RE: Change Order #2 Justification: Mountain View Whisman Solar Photo-Voltaic Project – Engie Services US Inc. – DSA Application No.'s 01-119500 (Bubb), 01-119501 (Landels), 01-119502 (Huff), 01-119503 (Graham), 01-119504 (Castro/Mistral), 01-119533 (Crittenden), 01-119534 (Monta Loma), 01-119535 (Theuerkauf)

Item #1 – Crittenden Middle School Canopy Revision (COR 2)

Change Order No. 02

Gabriela Mistral/ Mariano Castro Elementary School

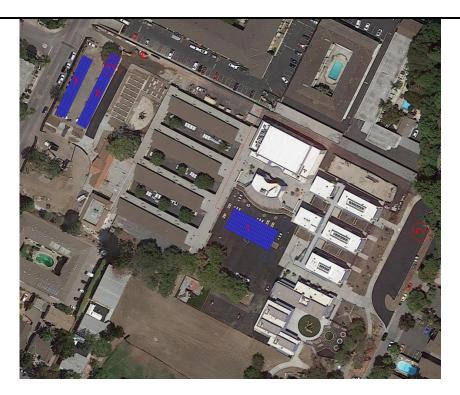
At Gabriela Mistral – Mariano Castro Elementary School, due to new information about an additional site electric utility meter and additional electric load, the system size shall be increased from 98.3 kWdc to 177.8 kWdc as shown in the site layout below. Expected 1st year PV output shall increase from 157,661 kWh to 275,565 kWh. The existing interconnection application shall be modified to include meter 1010282516 as a NEM-A benefitting meter in order to partially offset the load on this meter.

Two (2) fixed tilt single-cantilever carport DSA pre-checked structures or better. Expected characteristics: (i) 8 feet depth piers with no de-watering, benching, shoring, or casing; (ii) eleven (11) exposed concrete bollards above grade; (iii) 115 degree azimuth; (iv) up to 7 degree tilt; and (v) 12 foot clearance.

One (1) fixed tilt dual-cantilever carport DSA pre-checked structure or better. Expected characteristics: (i) 8 feet depth piers with no de-watering, benching, shoring, or casing; (ii) four (4) exposed concrete bollards above grade; (iii) 207 degree azimuth; (iv) up to 7 degree tilt; and (v) 12 foot clearance.

Remove one (1) tree from north of Array 2 and one (1) tree west of Array 3, as clouded in red in the layout below. In place of the trees that are being removed, Designer/Builder will plant two (2) new trees in a location to be mutually agreed upon by the District and Designer/Builder. District will be responsible for maintaining the new trees.

In order to maintain trees as much as possible and ensure maximum and guaranteed solar photovoltaic system generation, District will beresponsible for regular tree trimming and maintenance of the trees southwest of Array 1, as clouded in orange in the layout below, to not grow above 30 feet in height. However, Designer/Builder is responsible for any initial trimming required at the time of array or EV Charging installation.
